Our ref: L.A10908.002.00.Addendum01.docx

**RE: FLOOD ASSESSMENT FOR OAKDALE EAST INDUSTRIAL ESTATE MASTERPLAN AND
STAGE 2 WORKS - ADDENDUM NO. 1**

Figure 1.2 1% AEP Flow Hydrographs at the WaterNSW Pipeline Corridor

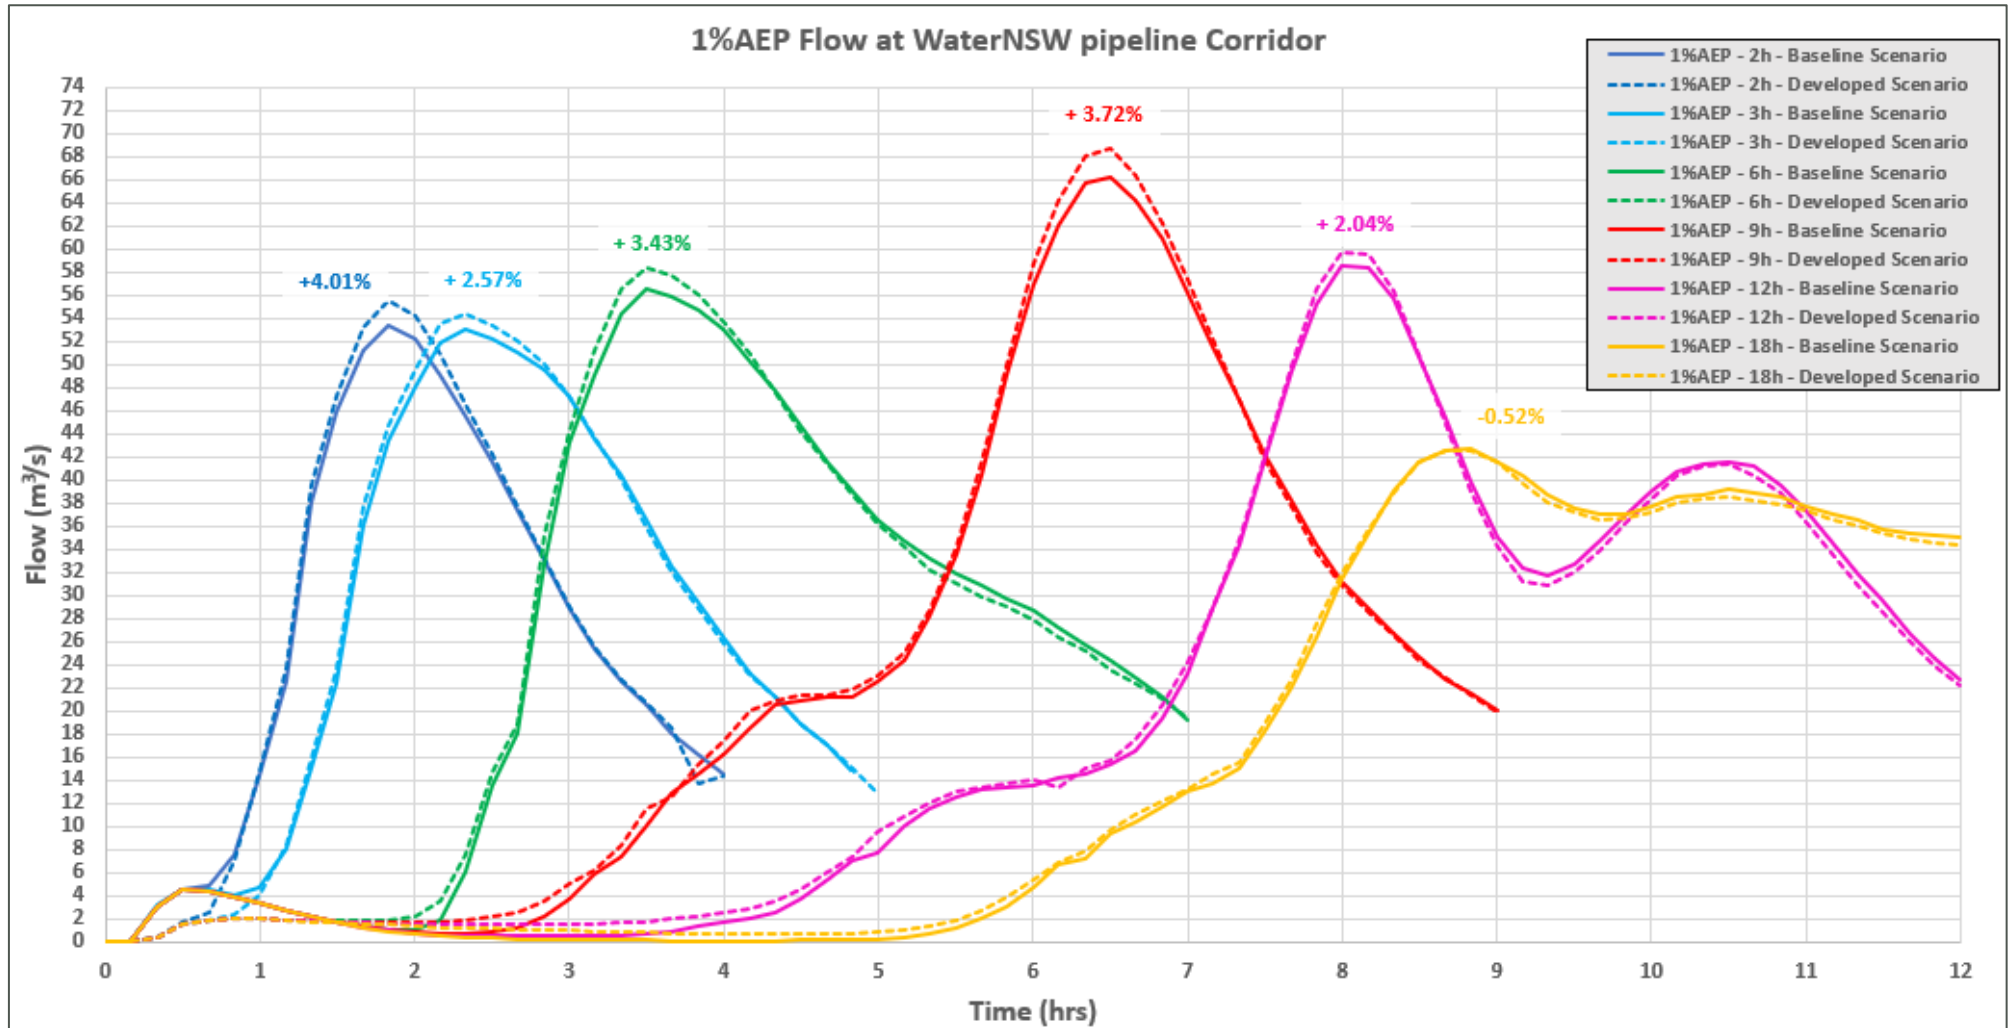
WaterNSW has reviewed the proponent's submission, which included the Oakdale East Flood Assessment, as well as Goodman's original Response to Submissions (RTS) dated November 2022, and has raised concerns regarding the adequacy of the proposed development to satisfy the requirement for post-development flows to be equal to or less than pre-development flows for each modelled storm event up to and including the 1% AEP event, particularly in the vicinity the WaterNSW pipeline adjacent to the proposed development site. This is outlined in WaterNSW's 'Response to Submission' letter dated 23 August 2022 (reference: D2023/1762).

Figure 1.2 and Figure 1.3 illustrate that, for all modelled storm durations, the timing of the flow hydrographs remains largely unchanged as a result of the proposed development works. However, an average relative increase in peak post-development flow of approximately 3% and 2% compared to the pre-development scenario flow is observed for the 1% AEP and 5% AEP events, respectively.

This increase is primarily due to the additional surface runoff generated by the proposed development and translates into a minor increase in velocity and water levels across the WaterNSW pipeline corridor, as presented in the mapping included in Oakdale East Flood Assessment. Specifically, the increase in velocity is typically less than 0.1 m/s for both the 1% AEP and 5% AEP floods, whilst increases in flood levels are predicted to be approximately 30 mm at the pipeline (i.e. Loc-G in Figure 1.1) for the 1% AEP flood and negligible at this location for the 5% AEP flood.

Our findings indicate that, whilst there is predicted to be a minor impact on peak 1% AEP and 5% AEP flows, it is unlikely to significantly impact on flow behaviour and flood conditions in the Reedy Creek floodplain in the vicinity of the Water NSW pipeline (as reported in the Oakdale East Flood Assessment), nor the flood risk to the WaterNSW pipeline and associated infrastructure downstream of the development.
